NATIONAL FIRE PROTECTION ASSOCIATION

TO: Technical Committee on Residential Sprinkler Systems

SUBJECT: NFPA 13R First Draft TC FINAL Ballot Results (A2027)

Figure 6.4.6.3.5.6 Positioning of Sprinkler to Avoid Obstruction at End of Hallway.

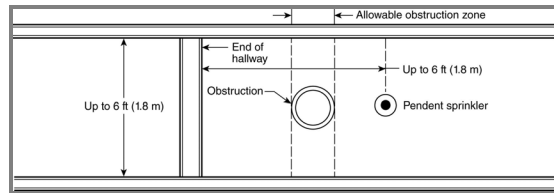
Committee Statement: Items such as exit signs, cameras and emergency lighting are commonly added and can be an obstruction to the sprinklers at the end of corridors/hallways. Water during discharge will spray hitting the close adjacent walls and provide water and cooling in the spaces all around the small obstructions.

In hallways up to 6 ft (1.8 m) in width and within 6 ft (1.8 m) to the end of a corridor, sprinklers shall be permitted to be located adjacent to obstructions where the sprinkler is installed in the allowable obstruction zone as shown in Figure 6.4.6.3.5.6 and the closest edge of the obstruction is a minimum of 12 in. (300 mm) away from the centerline of the sprinkler.

Figure 6.4.6.3.8.2(e) Obstruction Against Wall (Residential Sidewall Sprinklers).

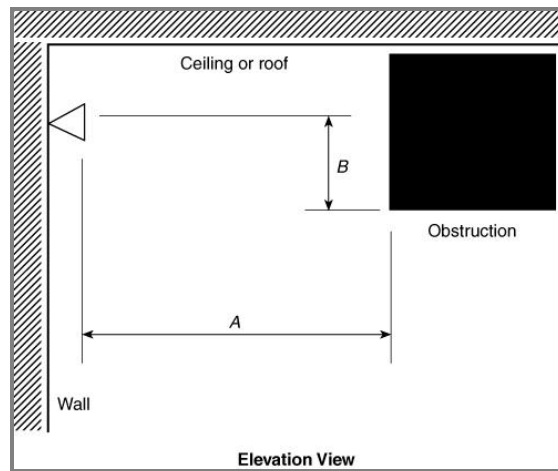
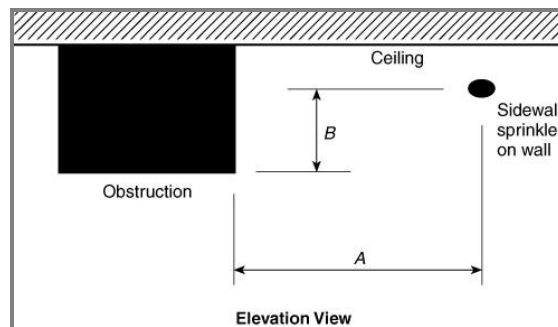
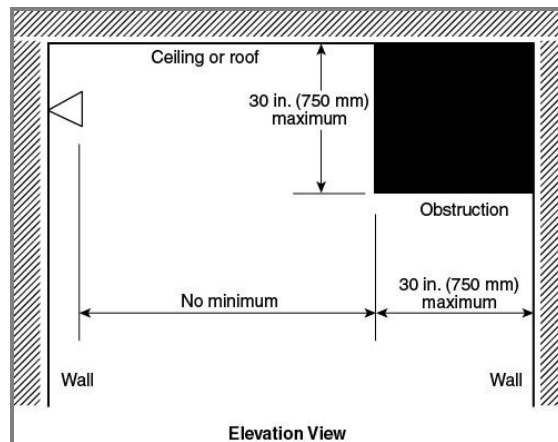
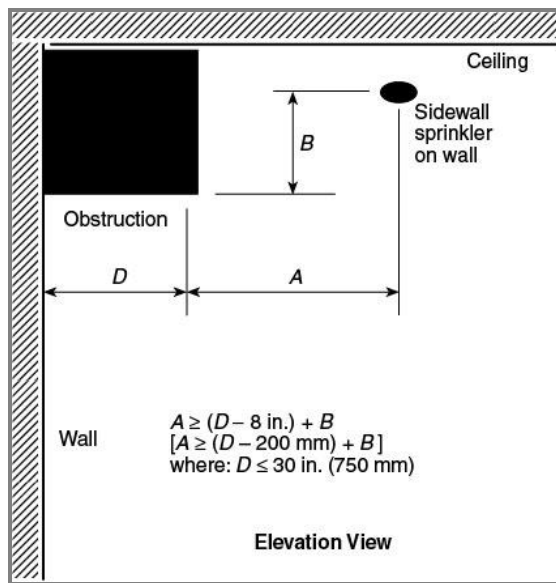
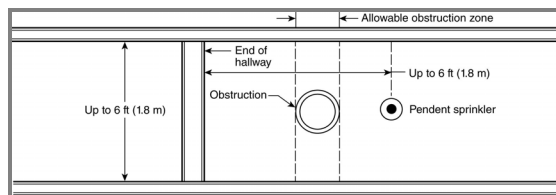
Committee Statement: Provides a figure for an obstruction scenario that was missing.

Sprinklers shall be positioned with respect to continuous obstructions in accordance with Table 6.4.6.3.8.2(a), Figure 6.4.6.3.8.2(a), Table 6.4.6.3.8.2(b), Figure 6.4.6.3.8.2(b), Figure 6.4.6.3.8.2(c), and Figure 6.4.6.3.8.2(d), and Figure 6.4.6.3.8.2(e).

Figure A.6.6.5.1.1.1 Sidewall Sprinkler Positioning Below Balconies and Decks Serving Dwelling Units.

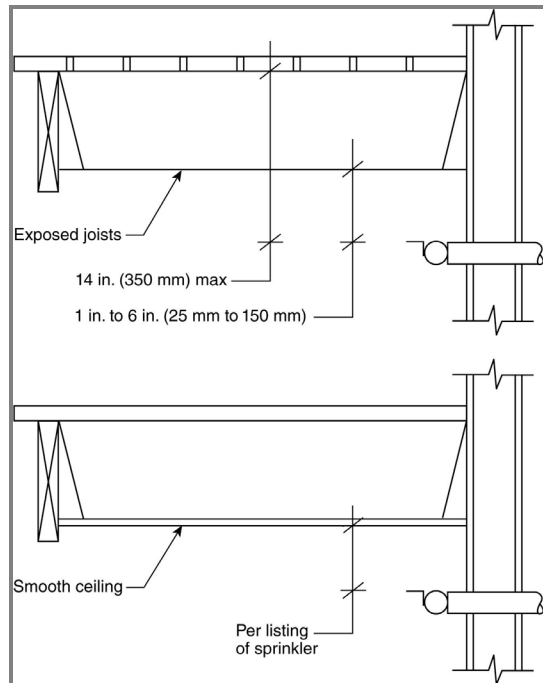
Committee Statement: This revision adds a figure to clarify the body of text.
